City of Denton

AGENDA INFORMATION SHEET

Hold a public hearing and consider adoption of an ordinance of the City of Denton, Texas, regarding a request for a Certificate of Design Consistency for a new two-story addition above the eastern portion of the structure facing S Austin Street and including modifications to the western and northern facades of the third floor of the existing structure facing S Locust Street and E Hickory Street at 101 S Locust Street, which is within the Denton Square Overlay Zoning District, and legally described as Parcels 1 and 2 of Block 8 of the Original Town of Denton, in the City of Denton, Denton County, Texas; providing for a penalty in the maximum amount of \$2,000.00 for violations thereof; providing for severability, and establishing an effective date. (DCC25-0007, Wells Fargo Addition and Modifications, Cameron Robertson)

Google Street View of Existing Structure, facing Southeast from the Square.

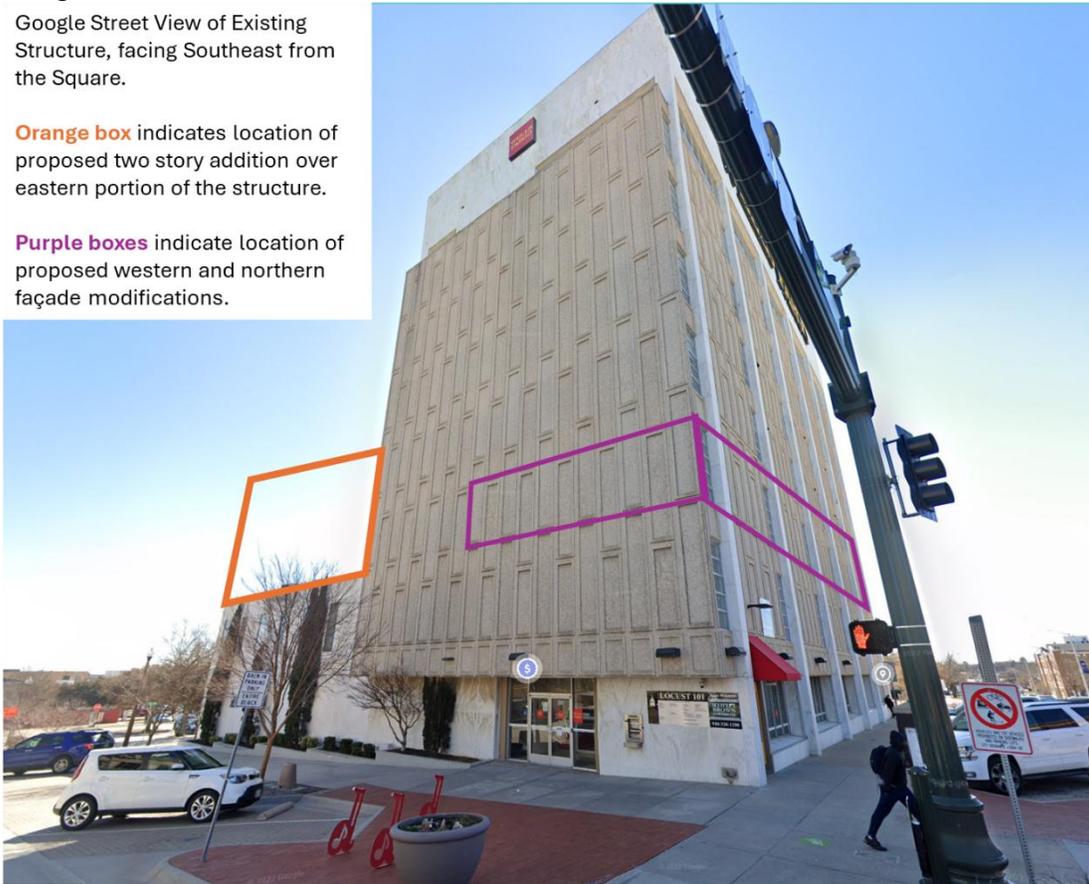
Orange box indicates location of proposed two story addition over eastern portion of the structure.

Purple boxes indicate location of proposed western and northern façade modifications.
